REMARKS

Application Serial No. 10/061,475

VERSION WITH MARKINGS TO SHOW CHANGES MADE

FIG. 14

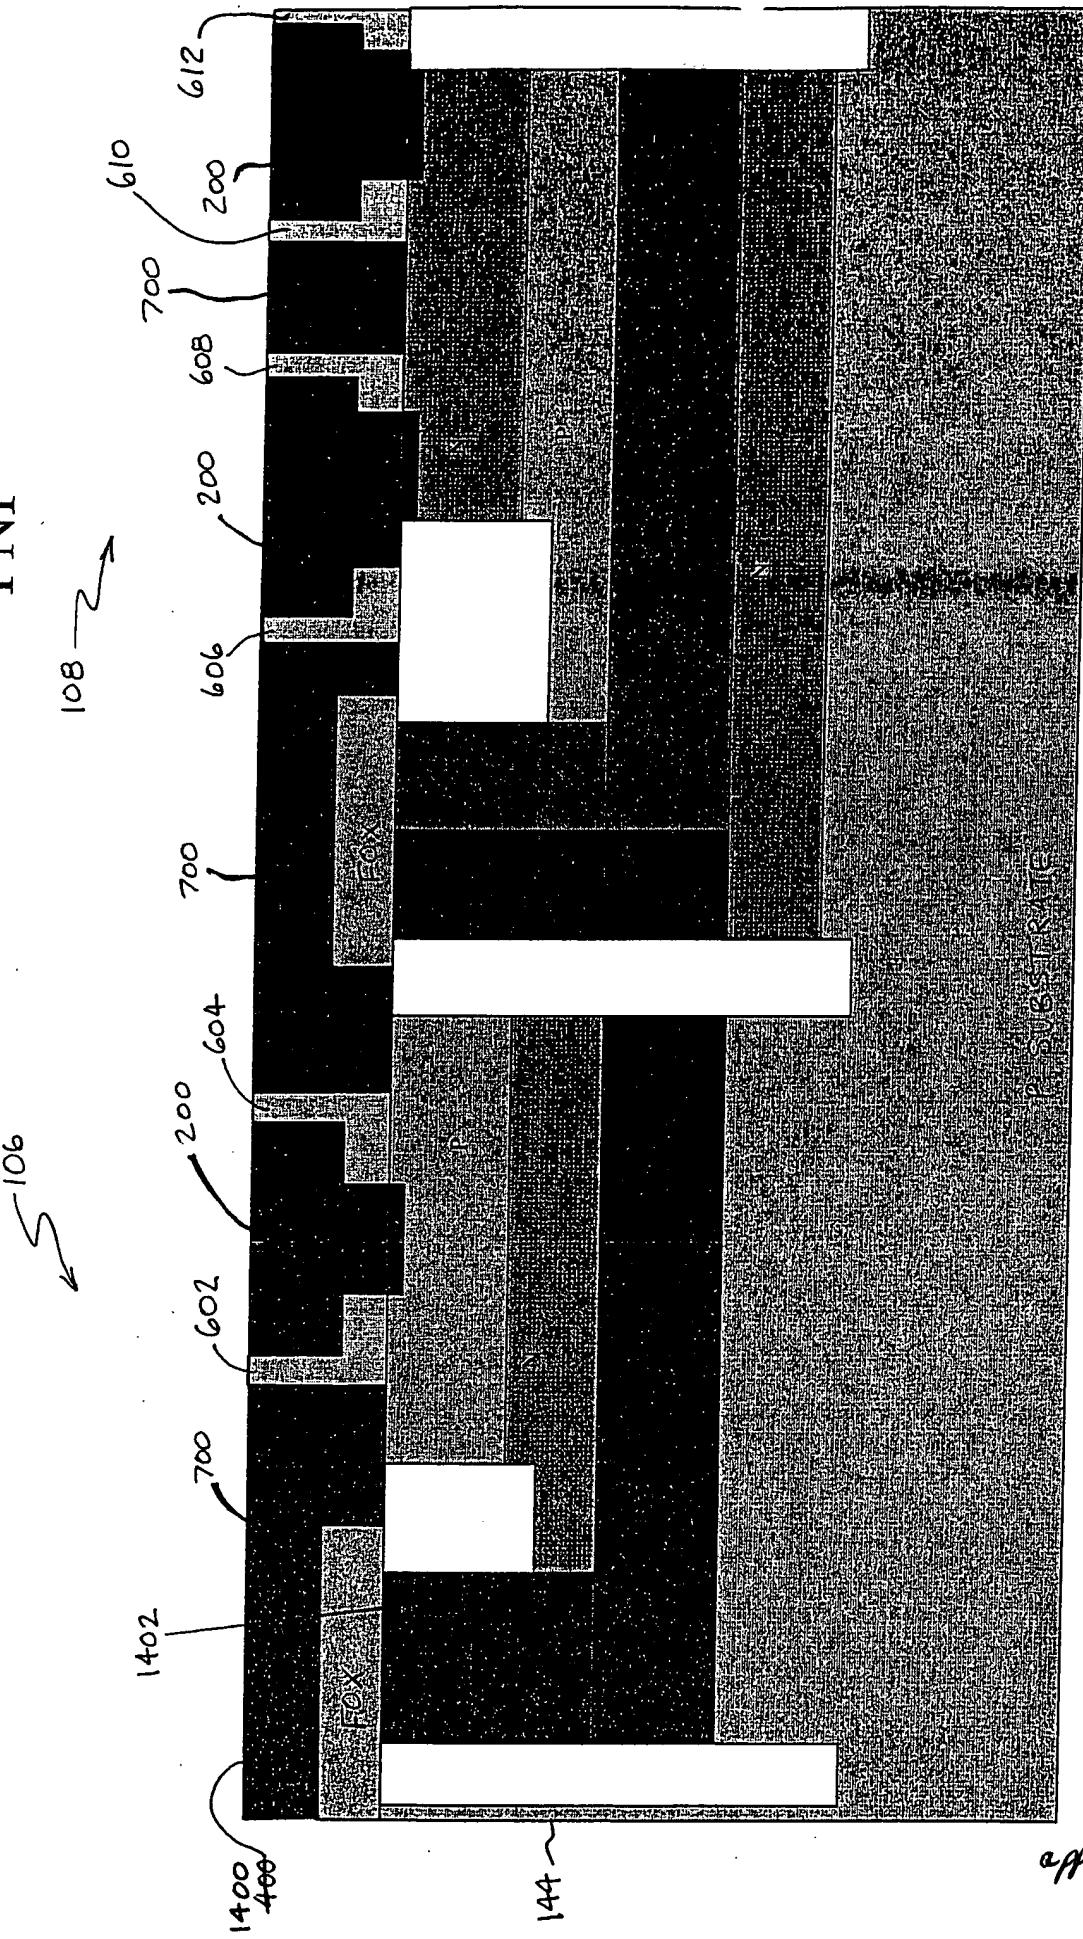
With regard to the Examiner's objection to the disclosure, Applicant submits herewith a proposed red-lined drawing change to FIGS. 13 and 14 of the drawings. Specifically, with regard to FIG. 13, reference numerals 200, 300 and 302 have been changed to 1200, 1300 and 1302, respectively, and with regard to FIG. 14, reference numeral 400 has been changed to 1400. The drawing changes are intended to cure certain informalities in FIGS. 13 and 14 and thereby provide

approved
Luke
